Space for Cycling Brisbane

10 June 2020

Cross River Rail Stakeholder Engagement Team

Thank you for your email of 8 June 2020 formally advising us of the Victoria Park temporary path closure and detour. We understand that to allow for work on the Cross River Rail project on adjacent land, the pedestrian and cycle path between College Road and the Victoria Park Land Bridge—colloquially known as "the Grammar Path"—will be closed from 22 June 2020 for at least 6 months.

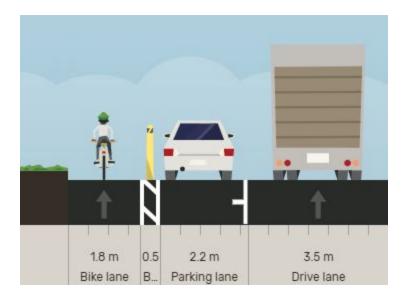
The painted on-road bike lane on Gregory Tce in this direction between Fortescue St and 95 Gregory Tce is problematic due to its proximity to parked cars, as described above. However we acknowledge that closing parking spaces here is likely to be contentious as there are more marked bays on this side (22), and these are available for long-term parking by residents with a permit. There is also a loading zone at 95 Gregory Tce. Fortunately, the footpath on this side of Gregory Terrace is wider and less cluttered than opposite. Although not ideal, cycling on the footpath when travelling in this direction is at least feasible, and thus an option for people who are not prepared to ride on the road.

- ★ Adjust the signal timing at the intersection of Gregory Tce and Fortescue St to make the pedestrian crossing more responsive.
- ★ Investigate closing car parking on Gregory Tce inbound between Fortescue St and 95 Gregory Tce, or alternatively:
- ★ Reverse the position of the bike lane and car parking in this section to provide a 1.8m wide bike lane next to the kerb, a 0.5m buffer (marked with paint and bollards or a temporary kerb), a 2.2m wide row of parking spaces, and a 3.5m general traffic lane.

★ Implement no-standing zones along Gregory Tce between 95 Gregory Tce and Wickham St where short-term parking is currently permitted at certain times, blocking the painted kerb-side bike lane.
